RE: Request for Amendment to Permit Application Package, Utah  
Power and Light Company, Deer Creek Mine, ACT/015/018,  
Folder #2, Emery County, Utah

Mine Water Discharge Deer Creek Portal

DEER CREEK MINE  
PROPOSED 18" Ø PVC  
DISCHARGE LINE

DSI223A

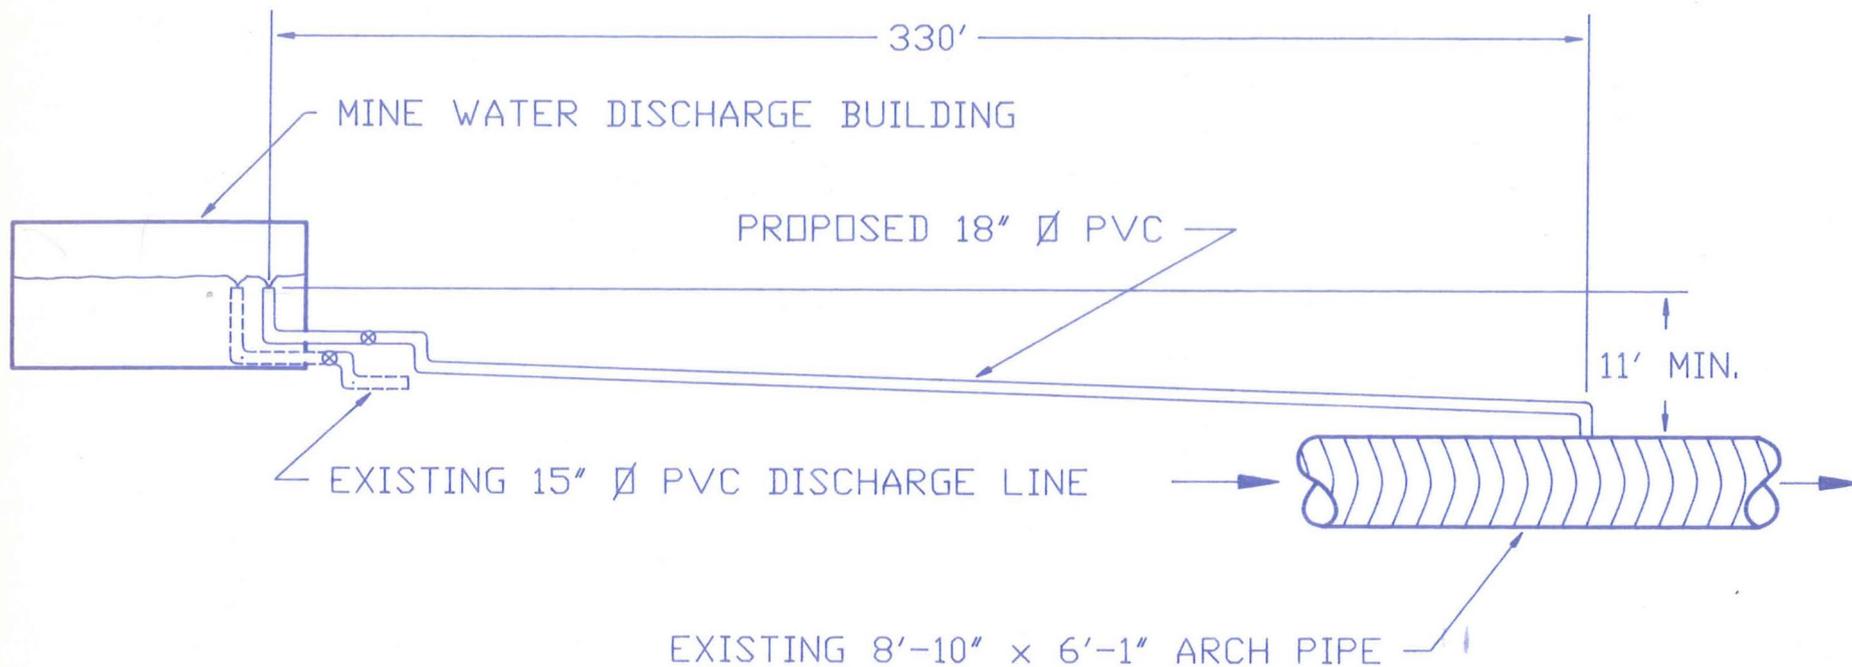
After meeting with the Health Department it appears that acquiring a Discharge Permit for the Deer Creek Portal can be realized within 2 weeks. Therefore, this submittal is simply requesting approval to bury an 18" pipe line running parallel with the conveyor belt for approximately 330' from the mine water discharge building to the undisturbed drainage culvert located east of the mine office parking lot.

Drawing DS1223A is submitted to provide further information for

your understanding of the proposed project. This drawing is not a part of the PAP.

The initial discharge into the undisturbed drainage will be approximately 2000 gpm or 4.5 cfs. The 18" pipe will allow us to discharge up to 10,000 gpm. The existing capacity in the culvert system as per the calculations in the PAP Appendix section indicates a capacity of 936 cfs. The runoff calculated for a 50 year/24 hour storm event is 917 cfs. Based on the 10 year/24 hour criteria the calculation for this area is 551 cfs as referenced in the PAP. Utilizing this criteria, the additional discharge water of 10,000 gpm (23 cfs) would not exceed the parameters of the 10 year/24 hour event.
